[Docket No. 2001-SW-53-AD]

Airworthiness Directives; Bell Helicopter Textron, A Division of Textron Canada Model 407 Helicopters

ACTION: Supplemental notice of proposed rulemaking; reopening of comment period.

Figure 1. Preflight Check of the tailboom

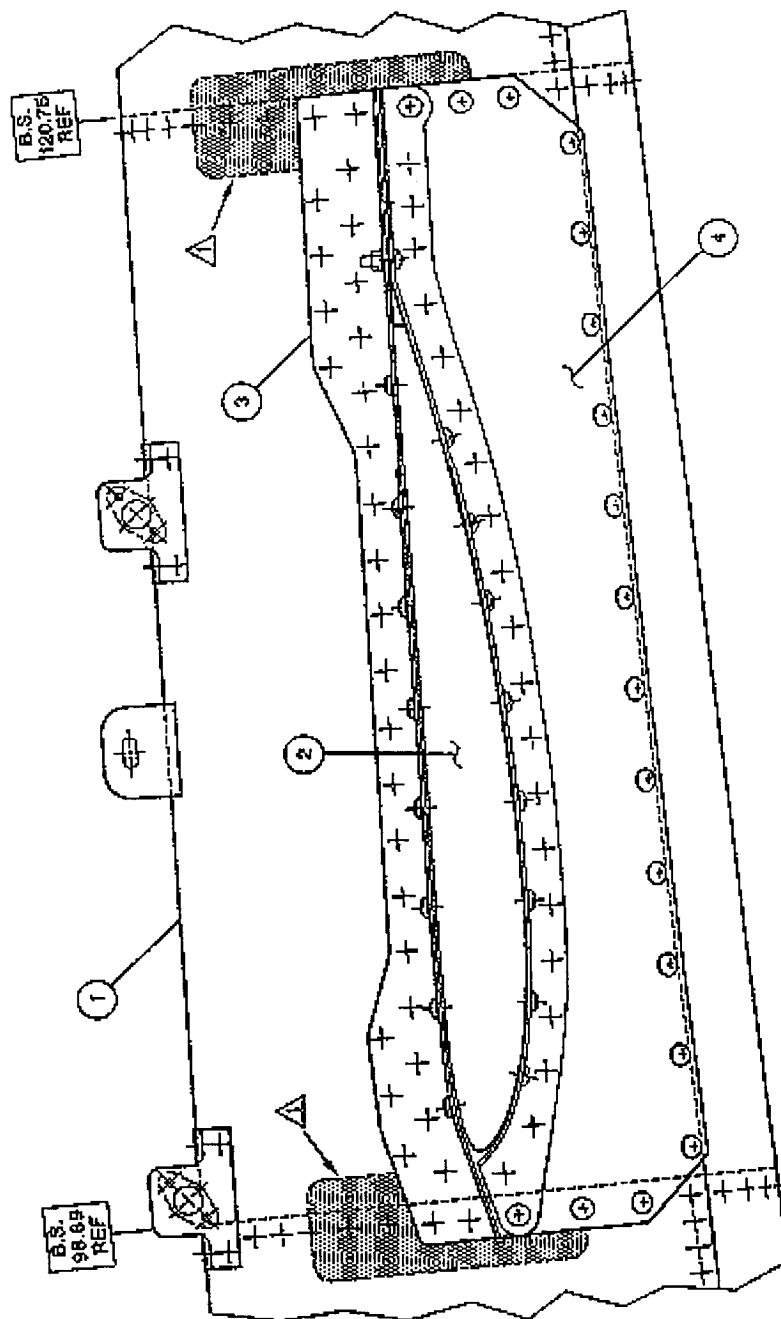
Applicable tailboom	Compliance time	Actions	In accordance with
(a) Tailboom, P/N 407-030-801-101 and -105, that have not been modified in accordance with Bell ASB 407-01-048, Revision B, dated April 25, 2002.	Before the first flight of each day	Visually check the tailboom for cracks. An owner/operator (pilot) holding at least a private pilot certificate may perform the visual check required by this paragraph, but must enter compliance with this paragraph into the helicopter records in accordance with 14 CFR 43.11 and 91.417(a)(2)(v).	Figure 1 of this AD.

- △ Examine these areas for cracks on left side of tailboom only.
2. Horizontal stabilizer not shown for clarity.
